ASSESSMENT REPORT

Building R1, Barangaroo South SSD 6513 MOD 2

Figure 3: Proposed Northern Elevation showing the relocation of the entry door and modification to the plantroom (Source: Applicant's architectural drawings).

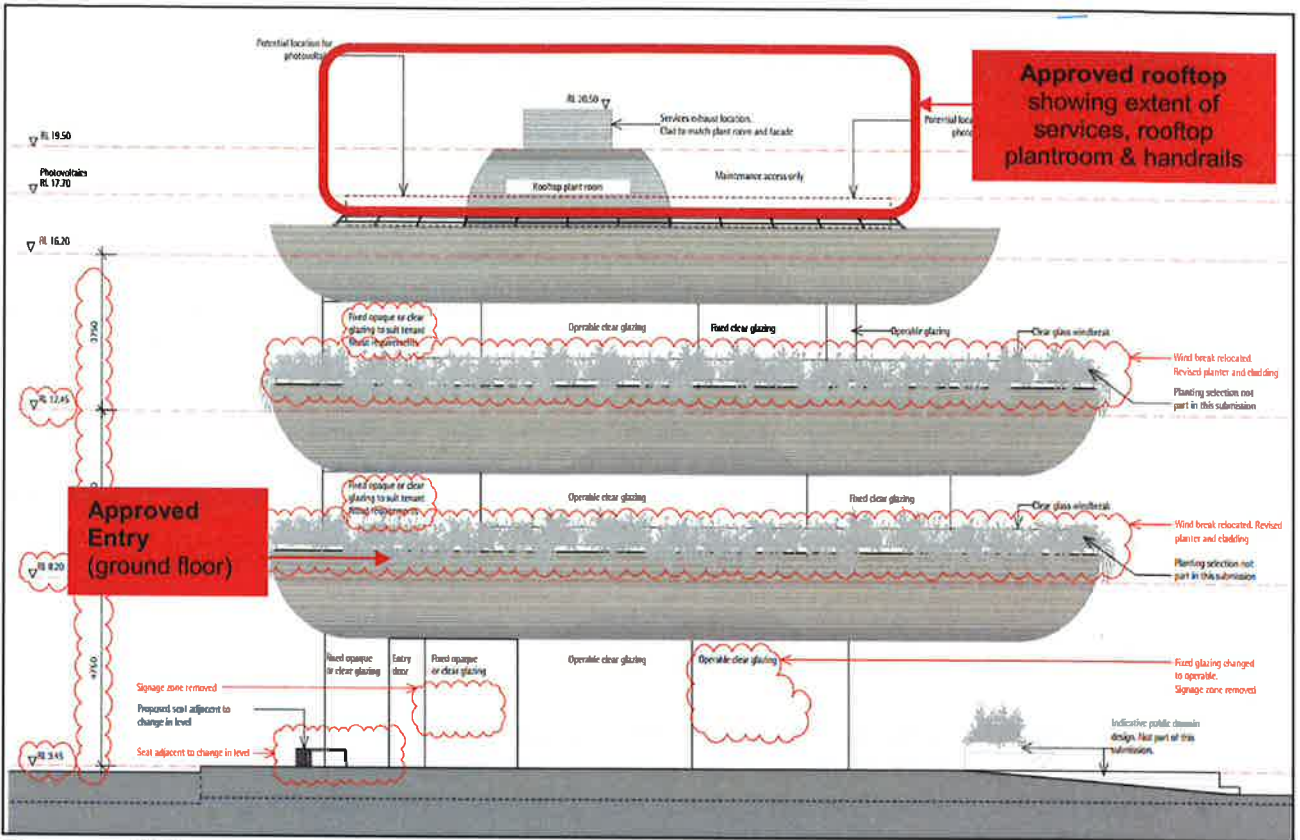
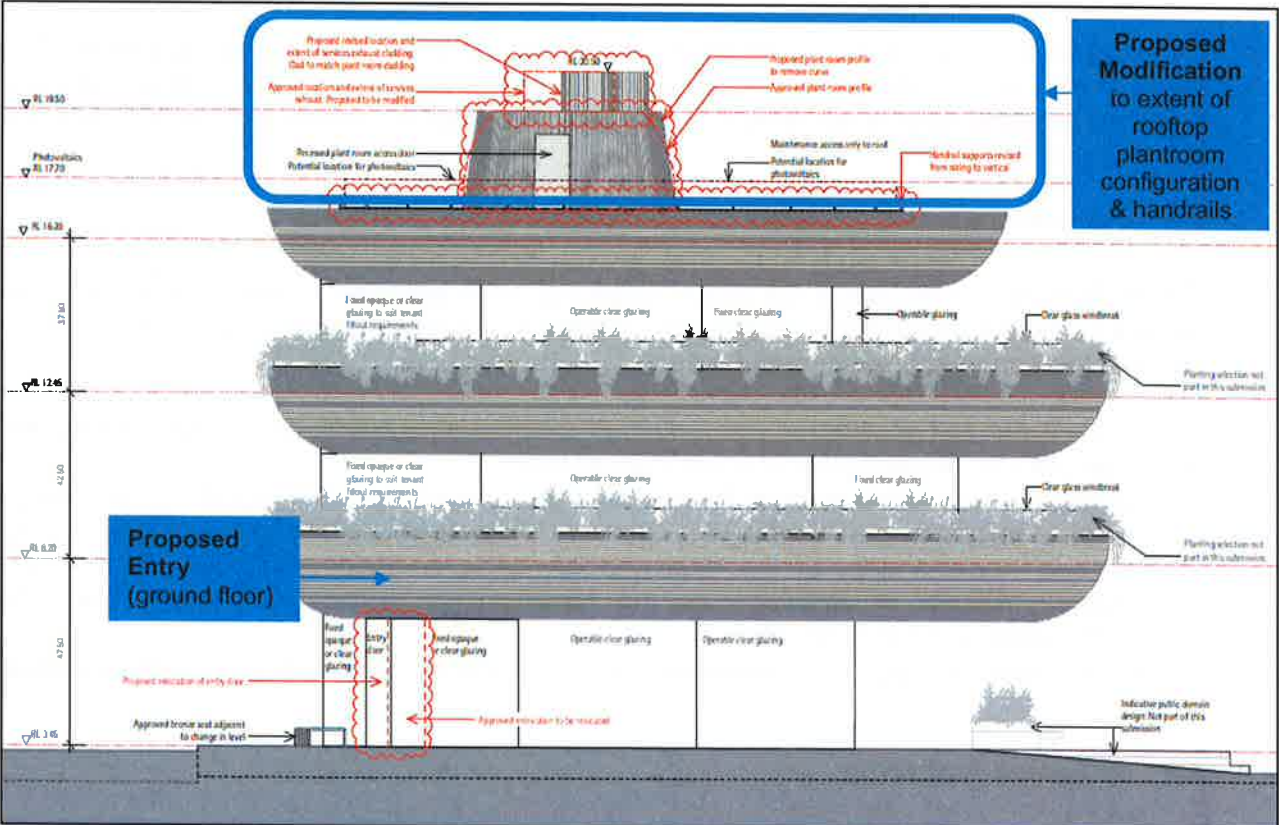
The Applicant seeks approval to relocate the entry door along the north-eastern elevation of the building and alter handrails associated with the stairs at ground level along the southern elevation.

The Department notes the entry door is being relocated only 1 m to the east of its current position and will not therefore not be perceptible nor materially alter the external appearance of the ground level façade of the building. The alterations of the handrails are similarly minor and will not give rise to public domain or accessibility issues.

The Applicant seeks approval to reconfigure the cladding treatment of the rooftop plant room to further conceal the plant room from view. The Applicant also seeks to reconfigure the design of the handrail at the rooftop of the building. The modifications are proposed to further improve the aesthetics of the approved building.

The Department accepts the modifications will not be visible from the public domain and will further conceal the visual appearance of the plant room, ensuring it reads as being an integral part of the design of the rooftop of the building.

The external ground level alterations are accordingly supported.

On this basis, the Department supports the proposed rooftop alterations.
